SAM DA1 Family Silicon Errata and Data Sheet Clarification

SAM DA1 Family Errata

2. Data Sheet Clarifications

2.3 Schematic Checklist - Crystal Oscillator (Chapter 41 of the Device Data Sheet)

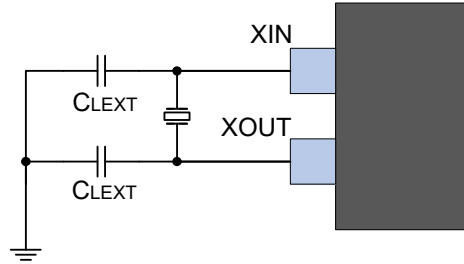
The load capacitor values shown in figure 41-6 and table 41-5 should not be used. C_{LEXT} should be calculated from the Load Capacitance Equation listed below. The corrected information is shown in **BOLD** type.

Load Capacitance Equation

$$C_{LOAD} = ([C_{XIN} + C_{LEXT}] * [C_{XOUT} + C_{LEXT}]) / ([C_{XIN} + C_{LEXT} + C_{LEXT} + C_{XOUT}] + C_{STRAY})$$

C_{LEXT} = Required external crystal load capacitor

C_{STRAY} (Osc PCB capacitance) = 1.5 pf per 12.5 mm (0.5 inches) (TRACE W = 0.175 mm, H = 36 μ m, T = 113 μ m)
